**Moorhead Area Public Schools
New Elementary School
Moorhead, Minnesota**

Project No. 15-025

Bid Date & Time: Thursday, April 21, 2016 at 2:30pm
Date: April 18, 2016

ADDENDUM No. 2

INTERIOR WALL TYPES

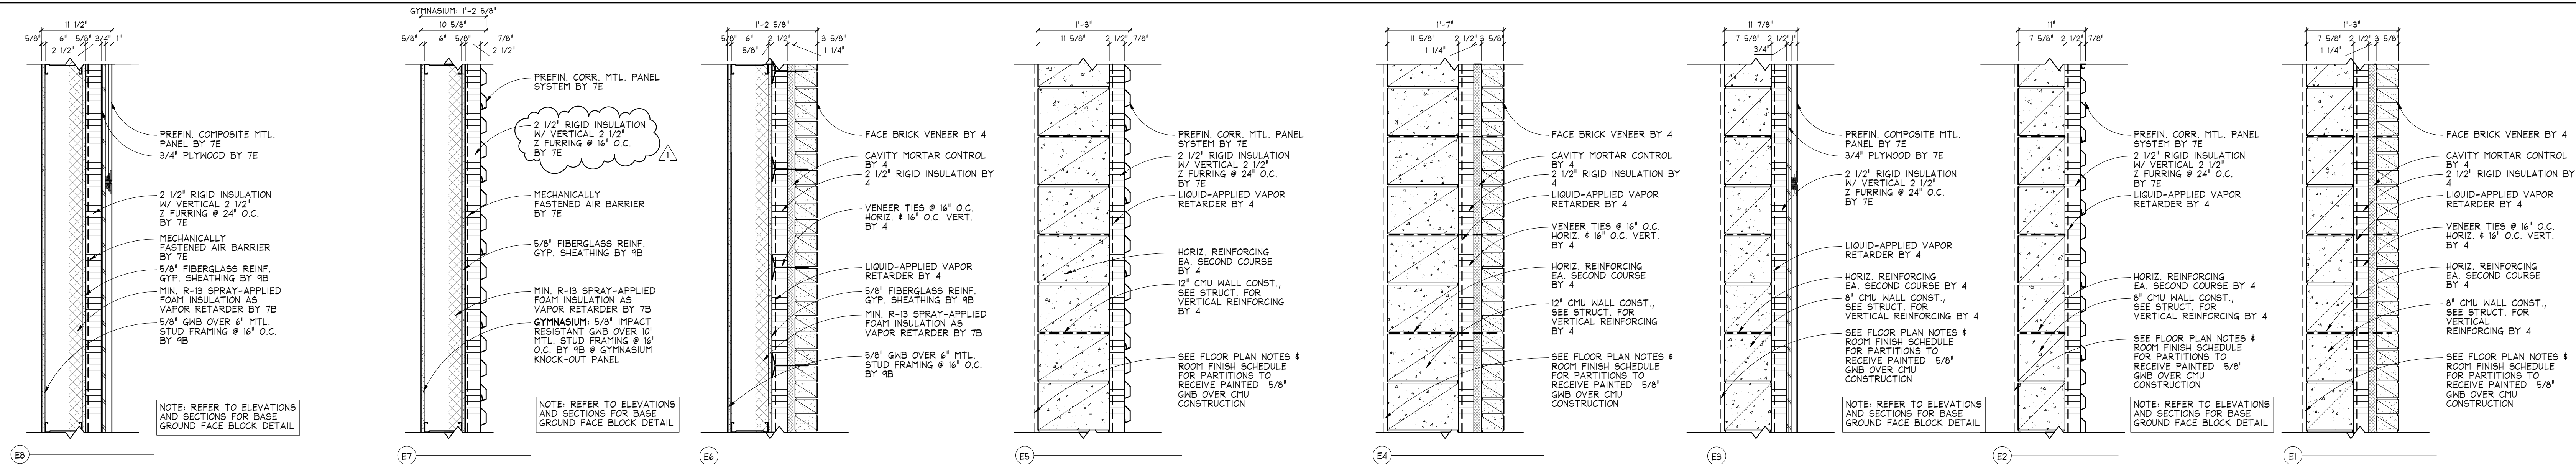
Sheet A0.5 – Partition Types

1. Interior Wall Types, Type S4 – see attached revised detail:
 - a. Add the following note: "@ 2-hour rated locations, (2) layers of 5/8" type X GWB on (2) sides of 3 5/8" mtl. framing @ 24" O.C. by 9B"
 - b. Add the following note: "Where indicated, partition shall receive a 2-hour rating, constructed per requirements of GA file no. WP 1522."

ENLARGED PLAN - AREA A

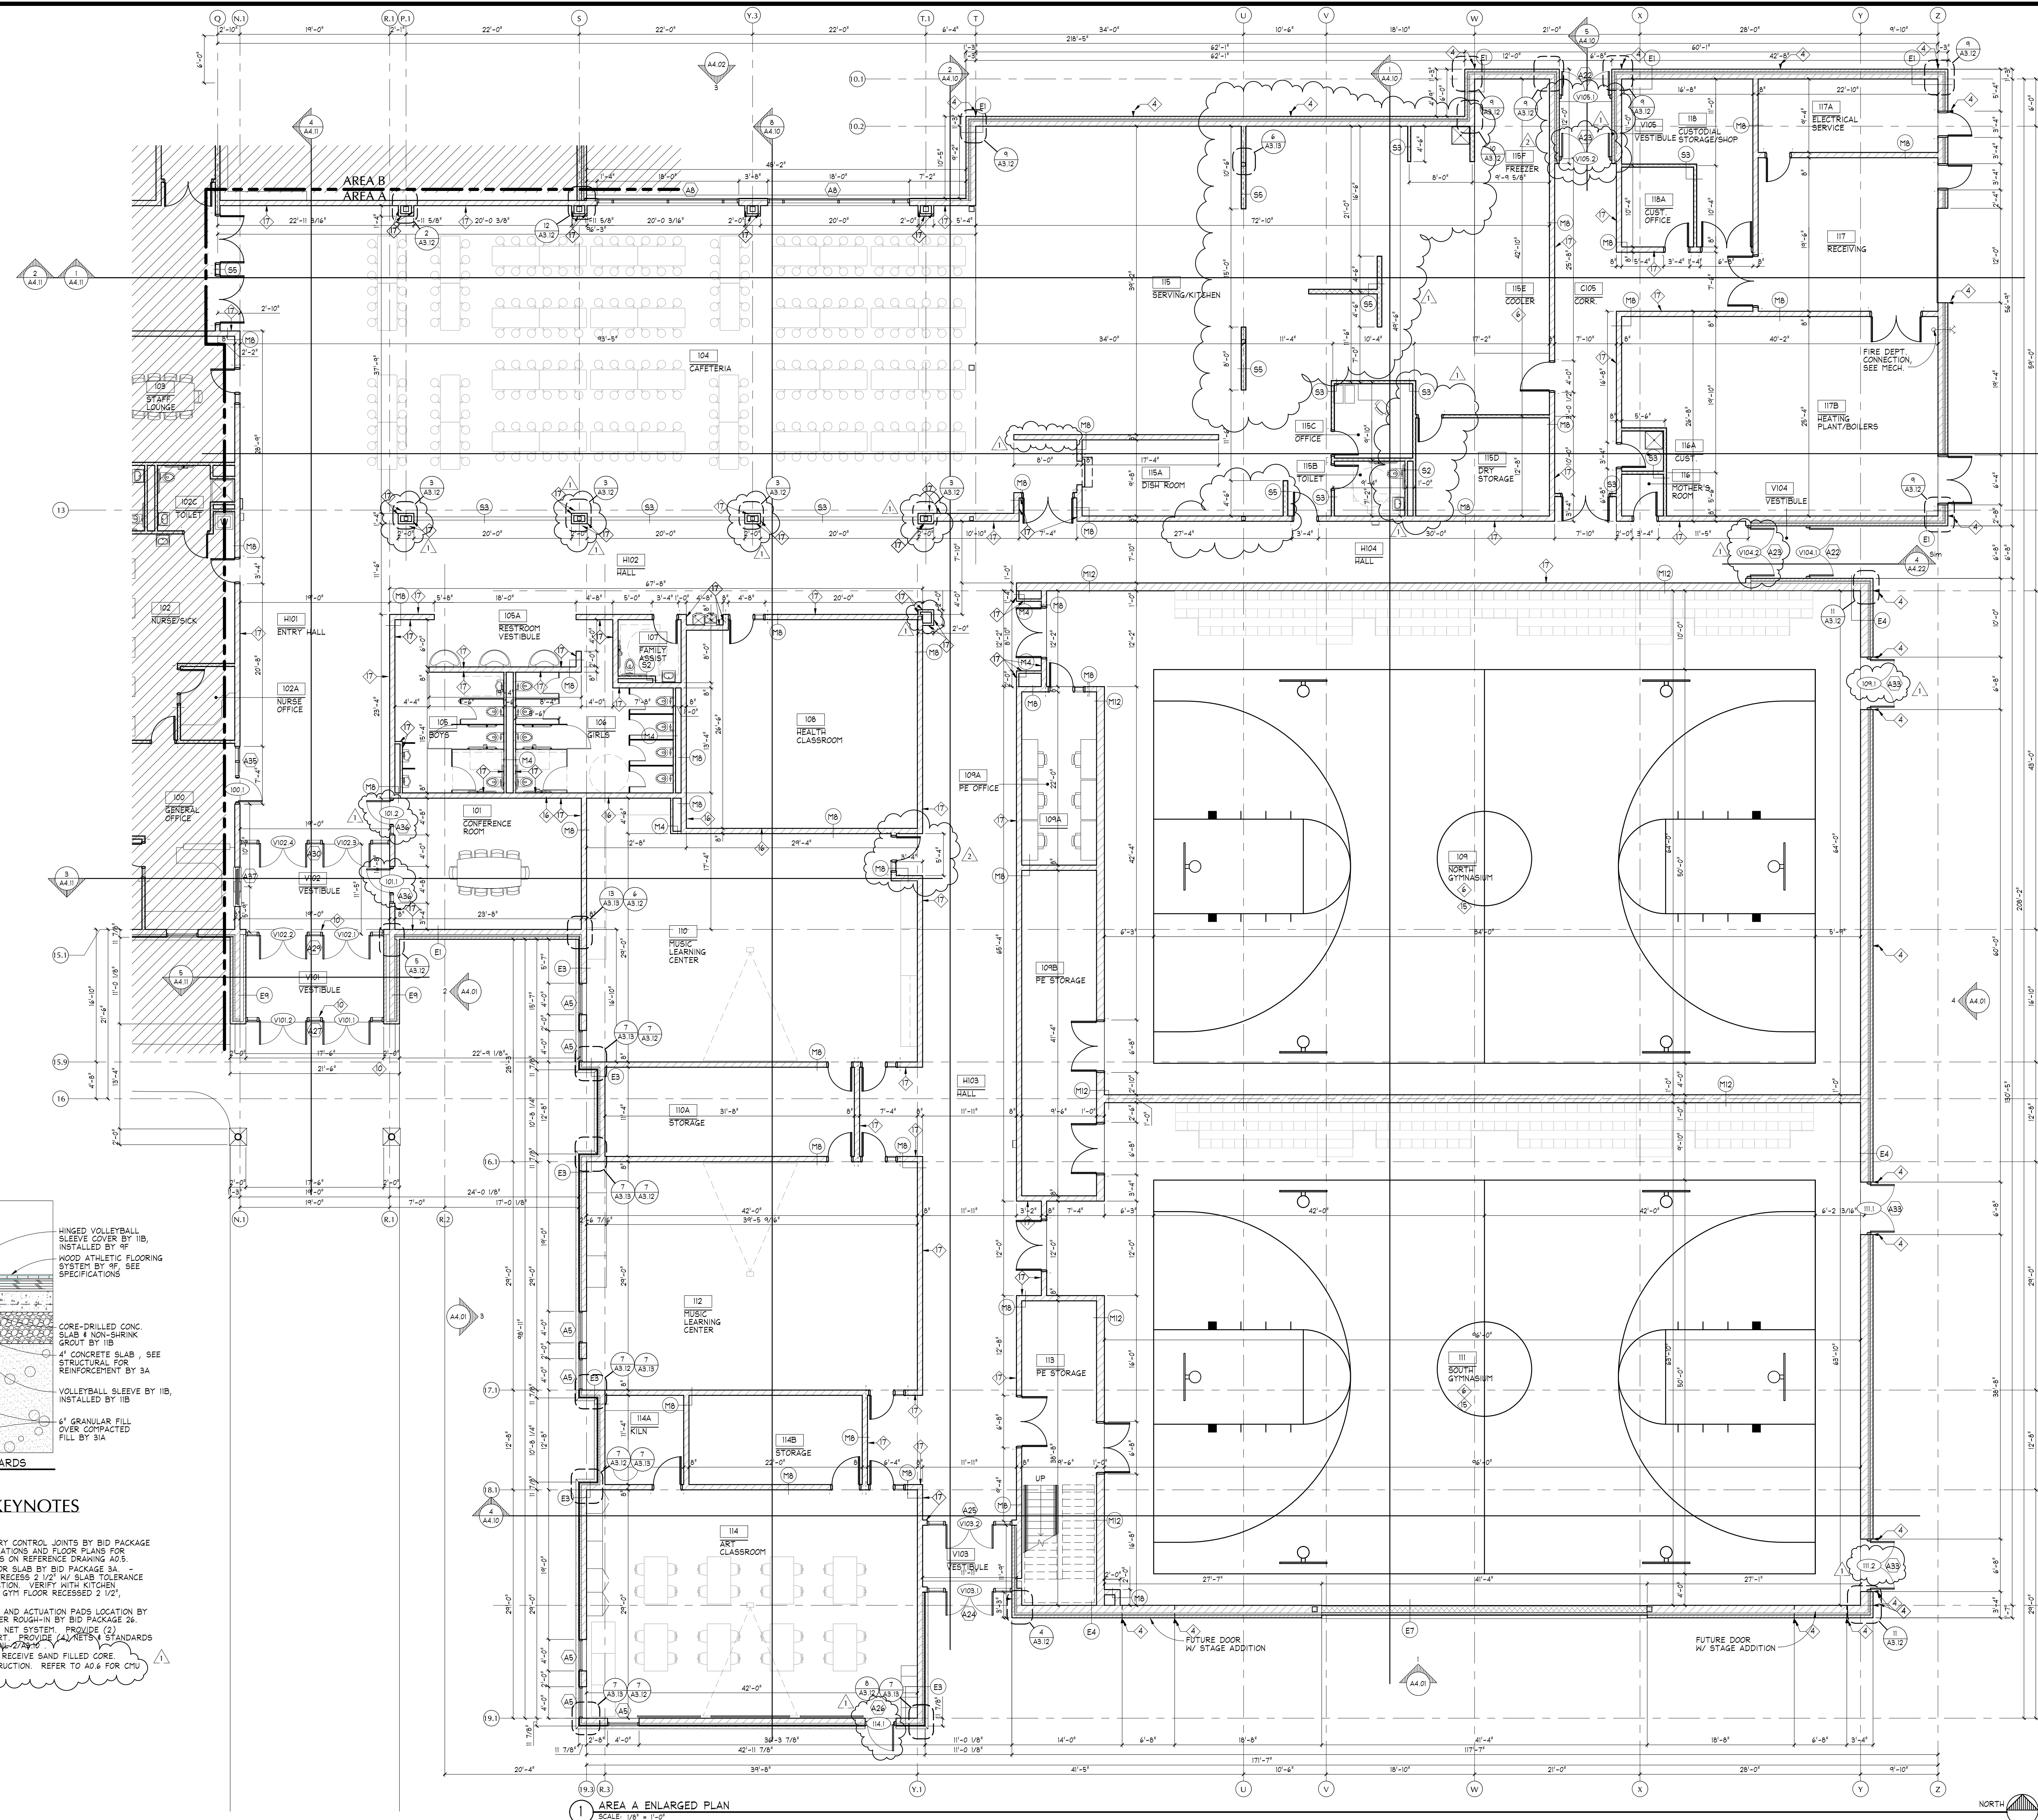
Sheet A3.10 – Enlarged Plan – Area A

1. Enlarged Floor Plan – Area A:
 - a. Revise plan to indicate wall type M8 in lieu of the previously indicated S5 at second exit from Music Learning Center 110.
 - b. Return face brick into Vestibule V105 as indicated on attached revised plan.

ENLARGED PLAN - AREA B

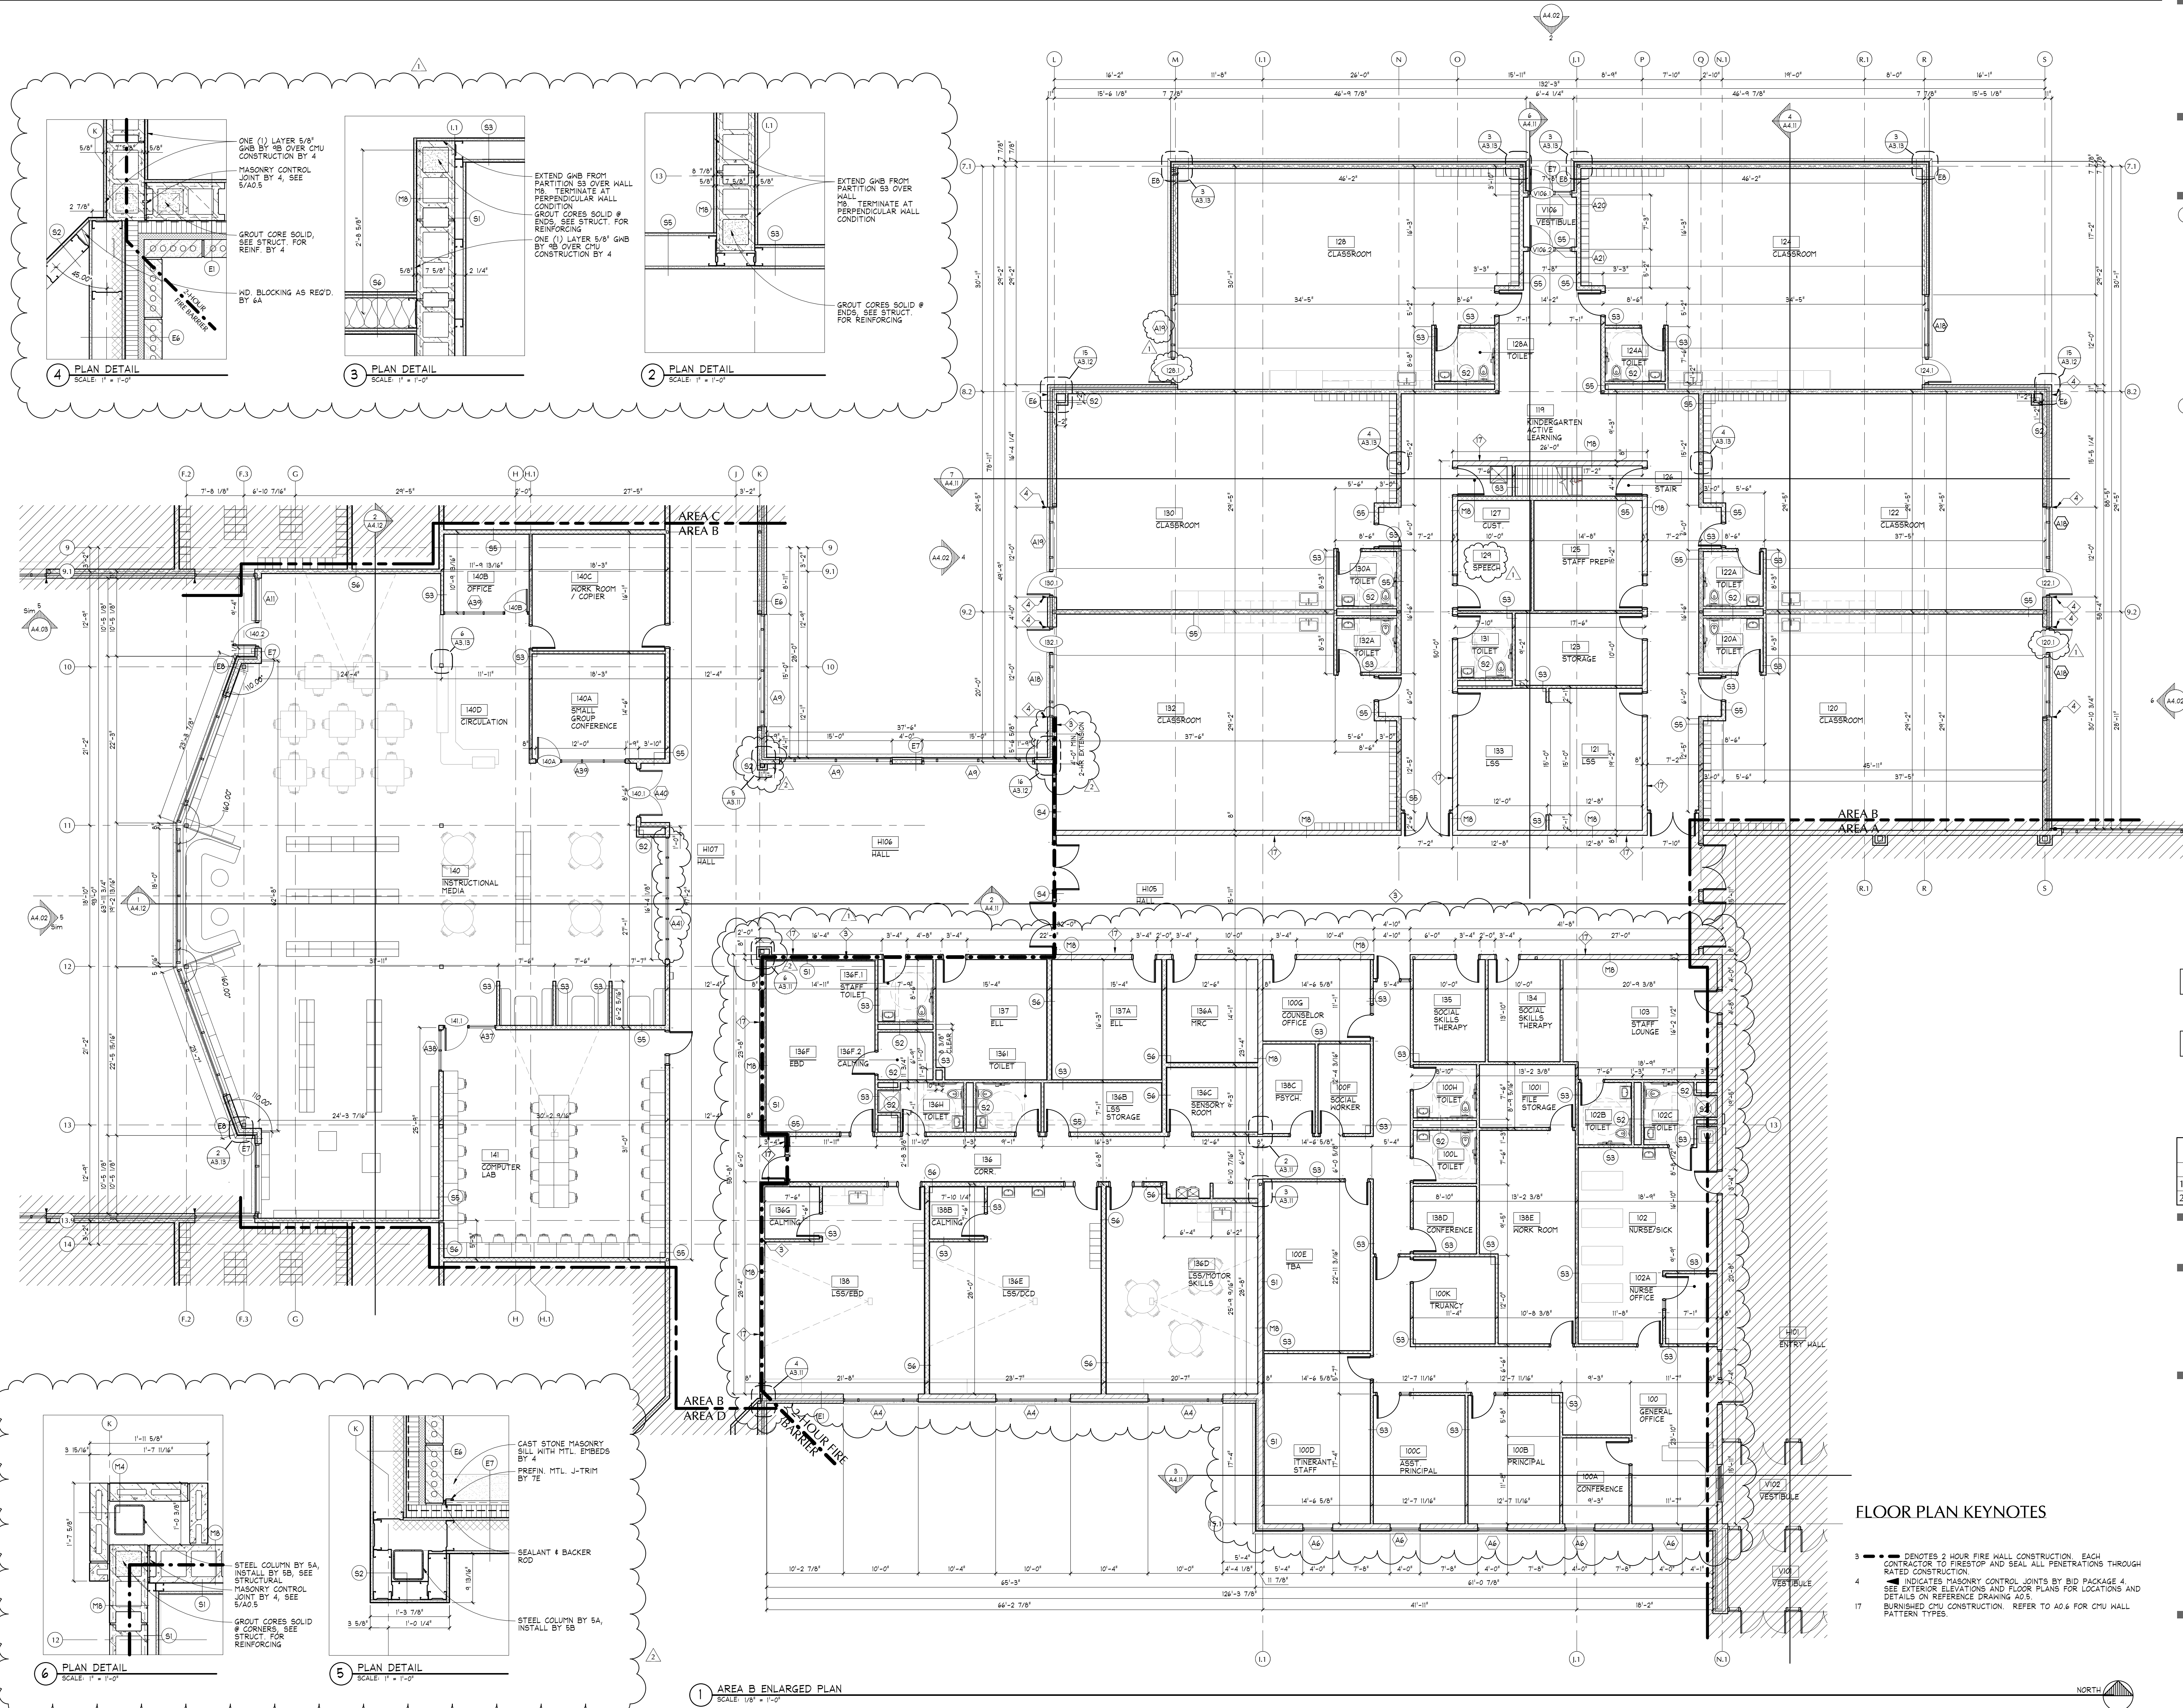
Sheet A3.11 – Enlarged Plan – Area B

1. Enlarged Floor Plan – Area B:
 - a. Add column wraps along grid K in Hall H06, see attached revised plan. Insert attached details 5 & 6/A3.11
 - b. Continue 2-hour fire wall northward into Classroom 132; terminate assembly at aluminum opening. See revised detail 16/A3.12.
